## Scope

An aftermarket replacement Valve Cover for OE part number 11 12 7 552 281, sold by company noted as OTHER, was reviewed using the tools, measurement equipment and quality verification processes in use at APA Industries. This report itemizes non-conformances found with the OTHER Valve Cover when compared to cover 11 12 7 552 281 from the original equipment manufacturer (OEM).

The OTHER brand Valve Cover 11 12 7 552 281 does not pass APA Quality Inspection.

Figure 1: OE Engine Head

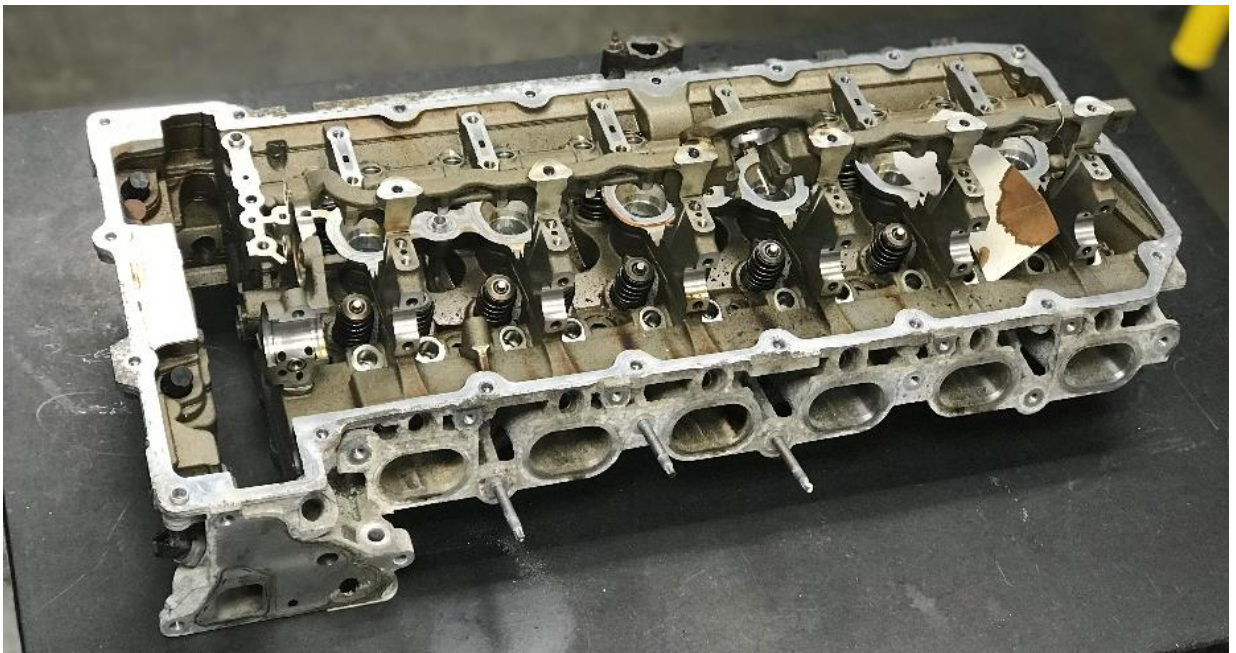
The OTHER valve cover was attempted to be installed on the OE Engine Head Shown in Figure 1. Installation was attempted by 4 other members of the engineering staff with the same result. The OTHER Valve cover does not fit the OE Engine Head properly. The installation attempts revealed 2 bolts that could not achieve proper fit and torque, shown in Figure 2 and Figure 3.

Figure 2c: Female fastener sleeve could not accommodate male locating feature.

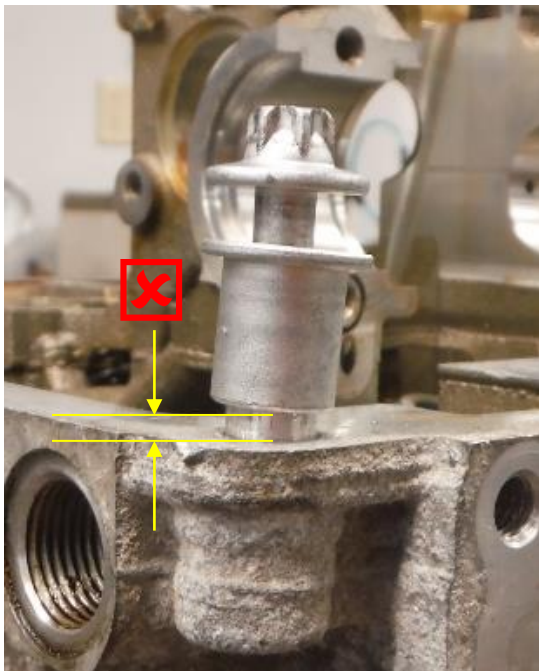
Figure 2d: Valve cover without bolt or sleeve. Housing must be forcibly deformed by installer to align fastener holes.

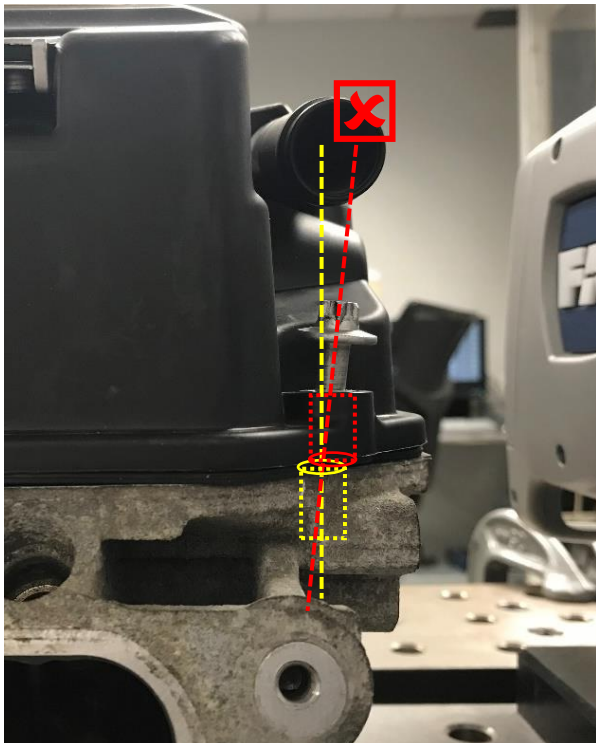
Valve Cover hole location creates a NG bolt angle (in red), which did not allow the fastener to be installed to proper torque.

Figure 4: CMM DATA: FARO ARM

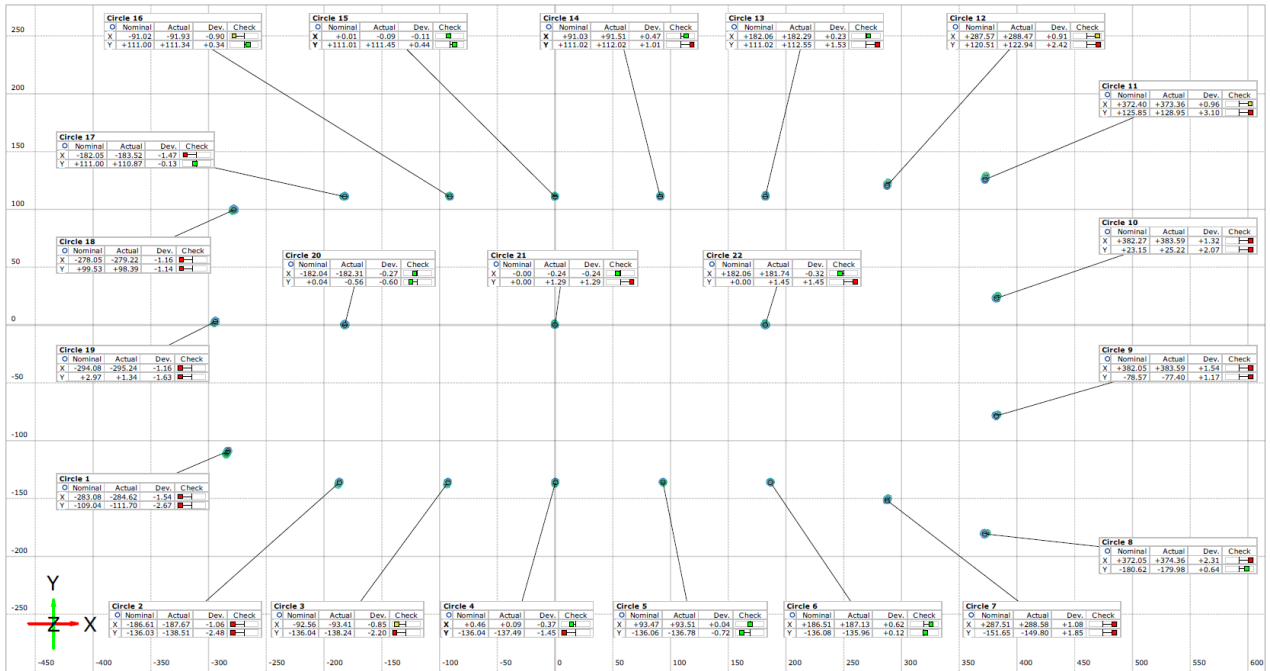
Applying a positional tolerance on each point of  $\pm 1.0\text{mm}$ , the OTHER valve cover has 17 out of 22 holes with a NG hole position in either the x-direction, y-direction, or both.

Additionally, the holes on the left side of the image, holes 18, 19 and 1, are off location in the X negative direction. The holes on the right side of the image, holes 11, 10, 9 and 8, are off position in the X positive direction. This is an additive situation. If you install a bolt into one end of the valve cover, all of the error is pushed to the other end of the part, causing the NG install experienced during the part fit activity.

Figure 5: Fasteners Falling Out

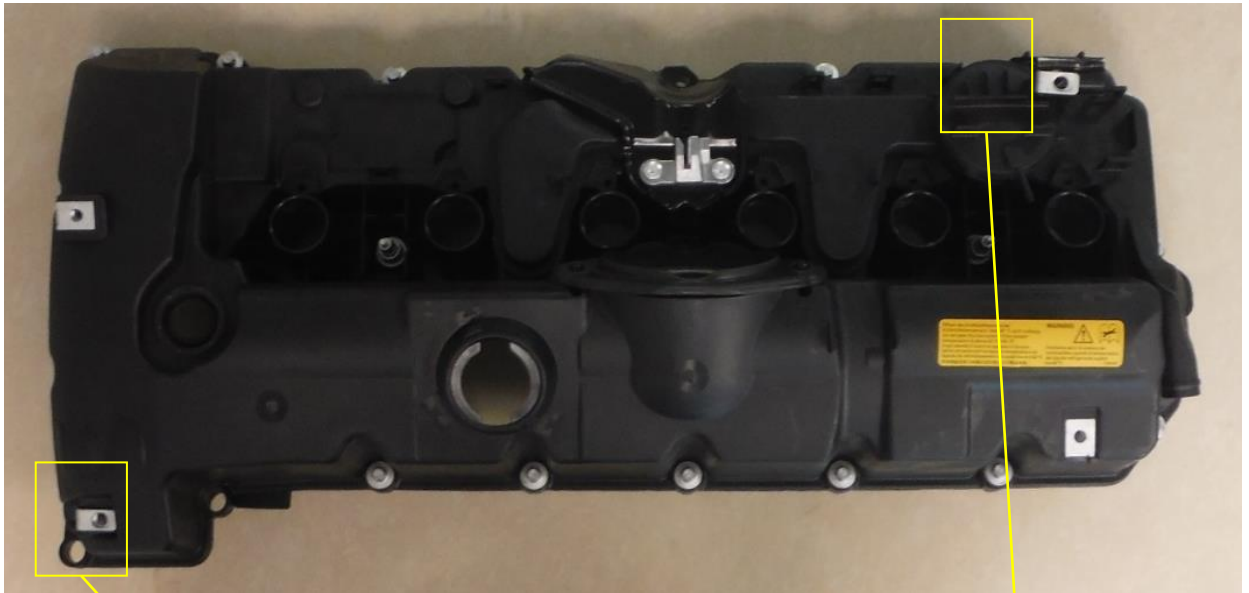
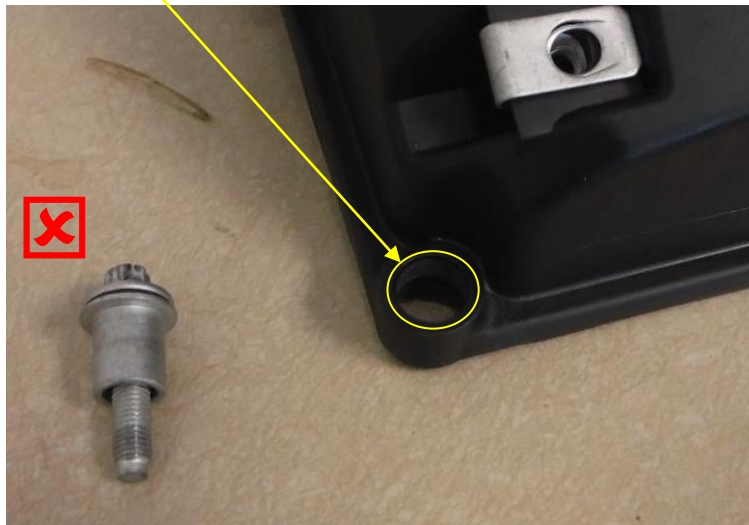
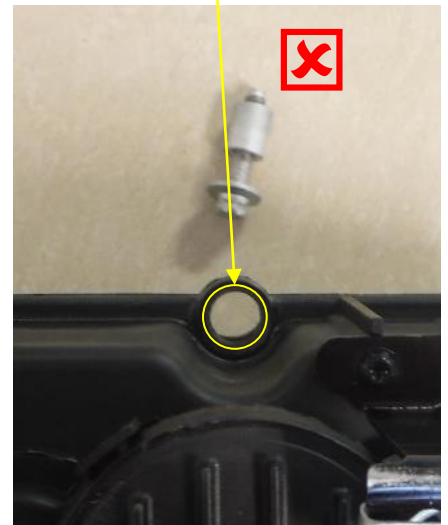
Upon unboxing, the fasteners shown in Figure 5 fell out of the valve cover assembly with little or no outside influence. This is not acceptable for customers. The cover molding must have a proper press-fit/interference fit between the valve cover main body and the fasteners.

Figure 6: NG Appearance - Tooling Marks

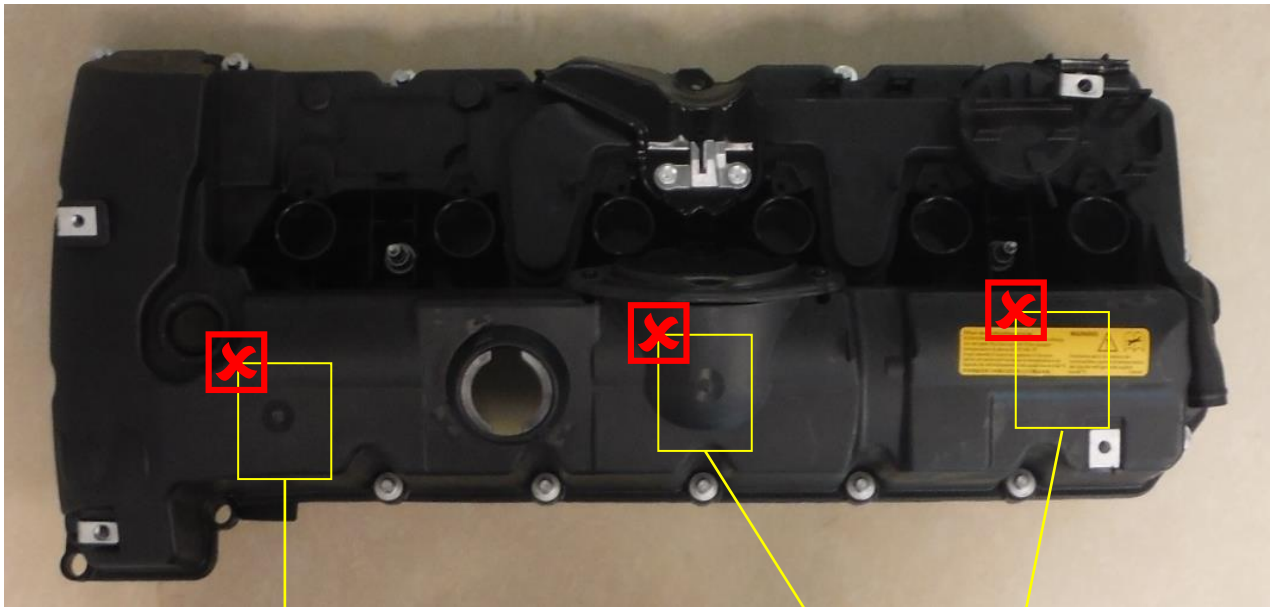
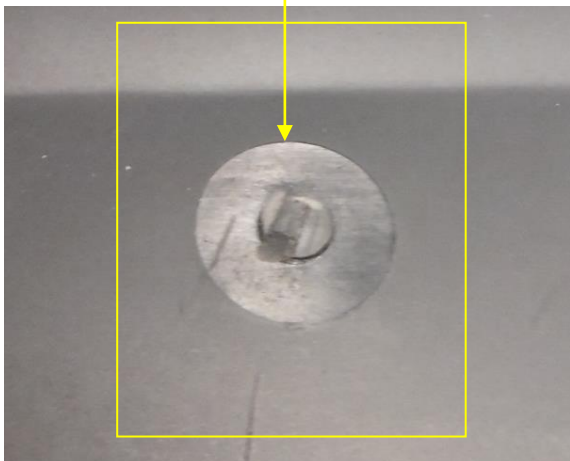
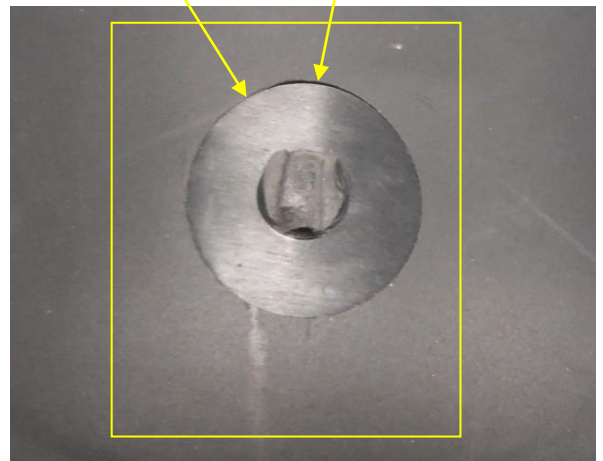
The main molding of the valve cover has rough tooling marks from the injection molding process. These marks are located on the top of the part, where they are visible in the engine bay of the automobile. This is an NG appearance for the customer.
